San Diego Gas & Electric Company's
Supplemental Filing Addressing
2020 Wildfire Mitigation Plan
Quarterly Report Insufficiencies

February 26, 2021

| | POLE MARKING INSTALLATION OF DELINEATORS | | | | |

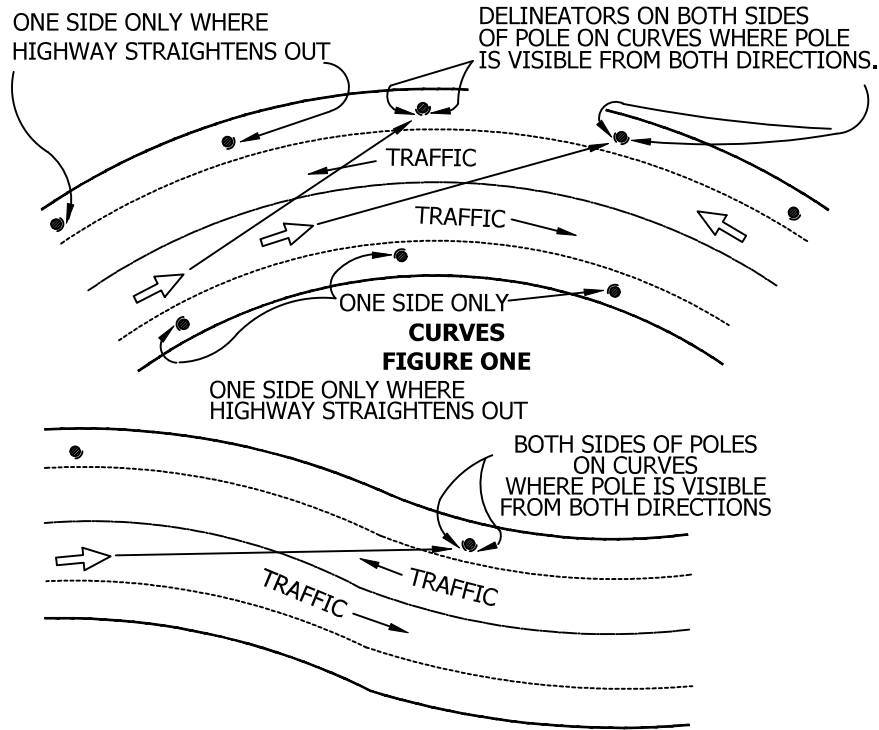
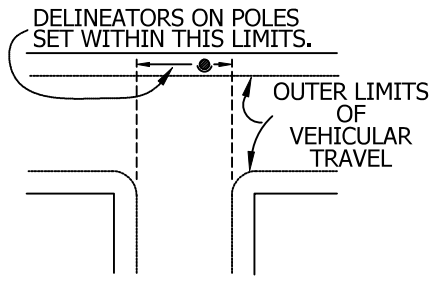
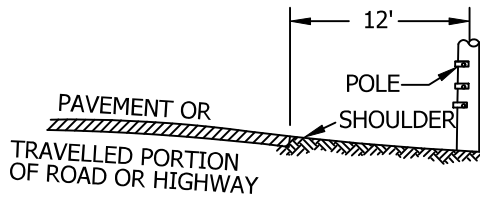
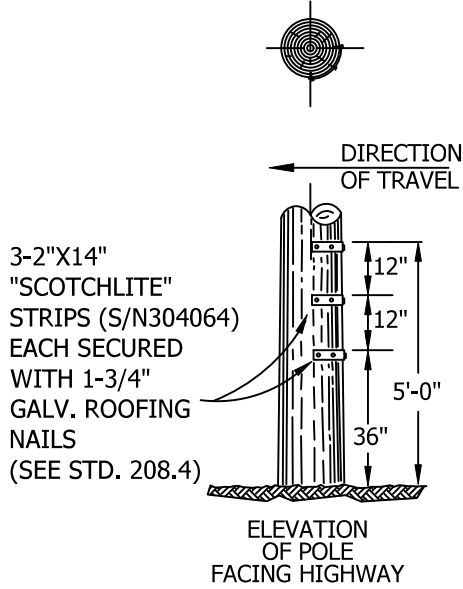
SDG&E shall: 1) provide its procedures, standards, and requirements related to increasing infrastructure visibility for the public (i.e., standards on visibility strips, signage, colorization), and 2) discuss how and whether such standards differ for areas of higher fire risk.

SCOPE: THIS STANDARD SHOWS VARIOUS EXAMPLES OF POLE DELINEATOR INSTALLATION.

SKETCH SHOWING METHOD OF MARKING POLES WITH DELINEATORS.

DELINEATORS ARE REQUIRED WHERE POLE IS:
 1. WITHIN 12' OF TRAVELED ROADWAY, OR;
 2. IN AN ALLEY.
